**S e r v i c e   N o t e**

<b>MODELS</b>	<b>CTH 130</b>	954140100 A
<b>AFFECTED:</b>	<b>CTH 150</b>	954140101 A
	<b>LTH 130</b>	954140107 A
	<b>YTH 150</b>	954140108 A & B
	<b>YTH 180</b>	954140109 A, B, & C

**SUBJECT:** Steering may not turn full right or left. Spindle arms may interfere with cast iron axle due to lack of washers.

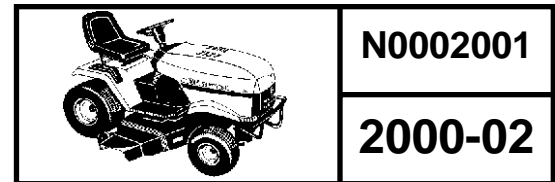
With the unit resting on a flat surface, turn the steering wheel for a full left and right hand turn. If either the left or right hand spindle arm interfere with the bottom of the axle, the unit must be reworked per the following instructions.

Remove the spindle assemblies, and add two washers (part # 532 12 17-49) to both sides. See diagram below.
